November 4, 2003

RE: Pilot study of Groundwater Conditions in the Joy Road, Mark West  
Springs, and Bennett Valley Areas of Sonoma County, California  
(The Kleinfelder Report)

I would like to share with you my comments on Kleinfelder, Inc.'s report on water scarce areas in Sonoma County, dated September 17, 2003. Immediately below, these comments are summarized. More detailed comments follow in the order of the report. "Appendix A" gives details on easily obtainable well data that Kleinfelder did not examine.

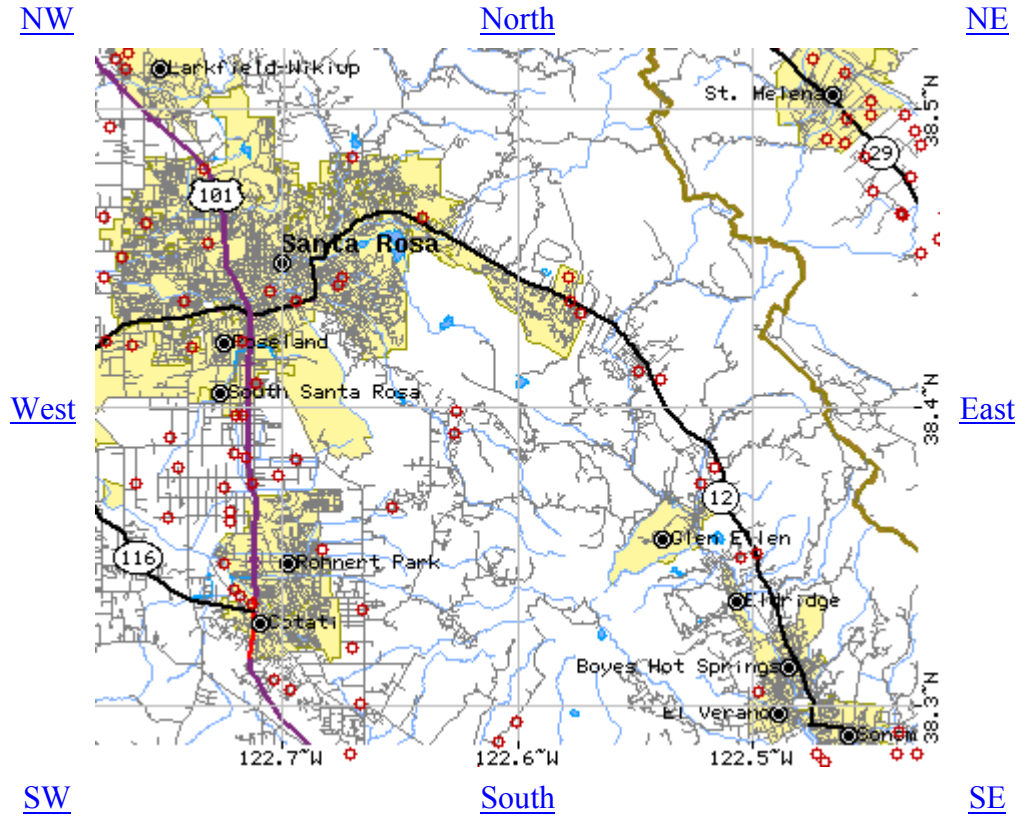
*“However, there are no Department of Water Resources monitoring wells near the study areas...”*

This statement by Kleinfelder is false! There are two (2) DWR monitoring wells within the Bennett Valley Study Area. Groundwater level and water quality information for these wells is easily obtainable through the DWR Water Data Library at this website:

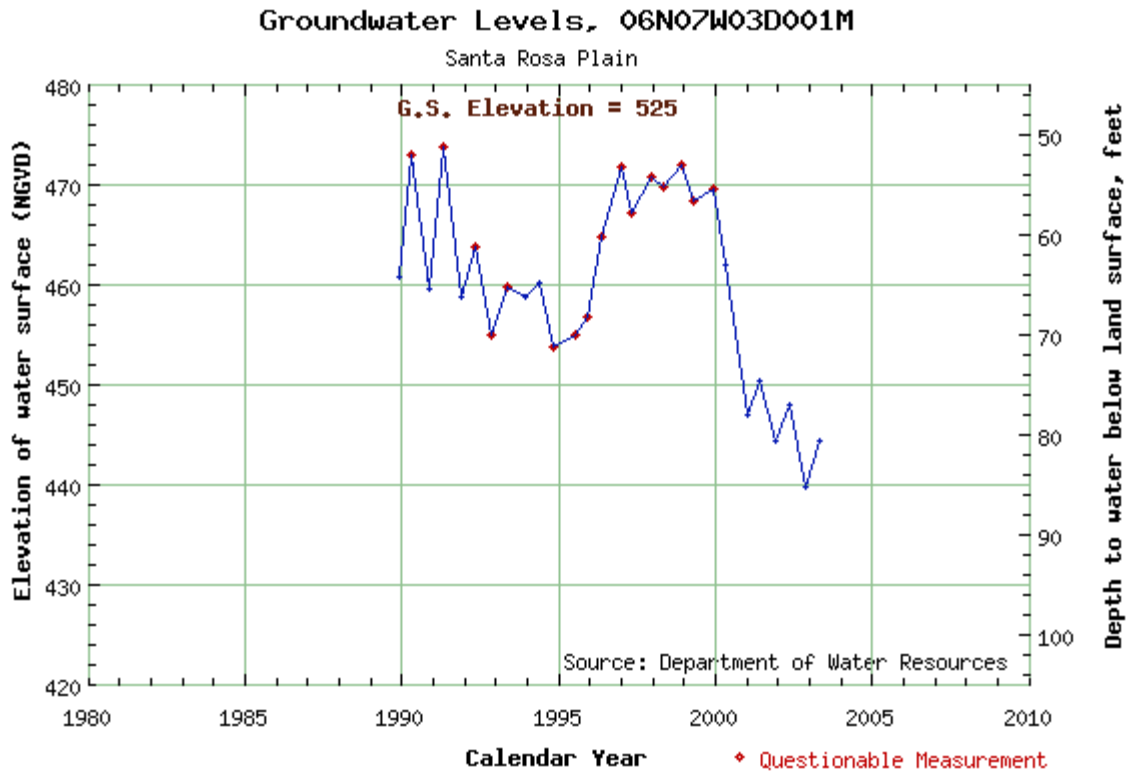
A map interface provides an easy way to find DWR monitoring wells:

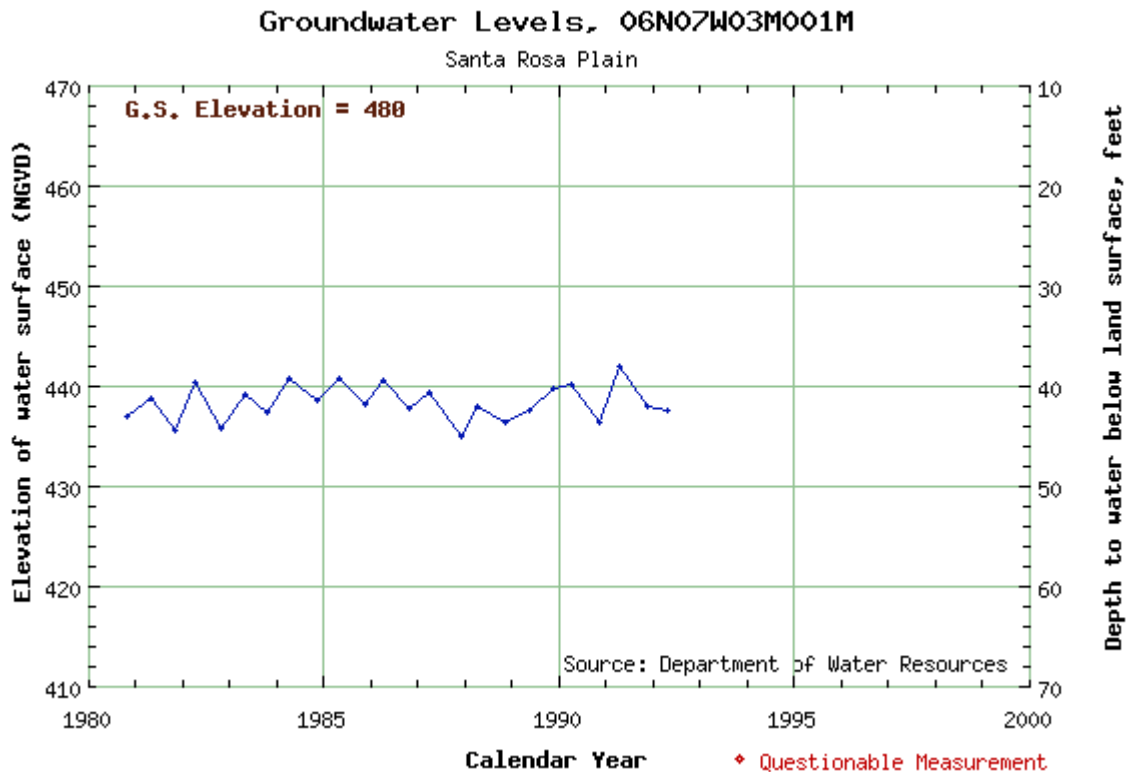
Water level elevations in DWR well 06N07W03D001M indicate an approximate 30 foot water level decline between 2000 and 2003:

Water level elevations in DWR well 06N07W03M001M appear stable over time. However, no water level data are available after 1992:
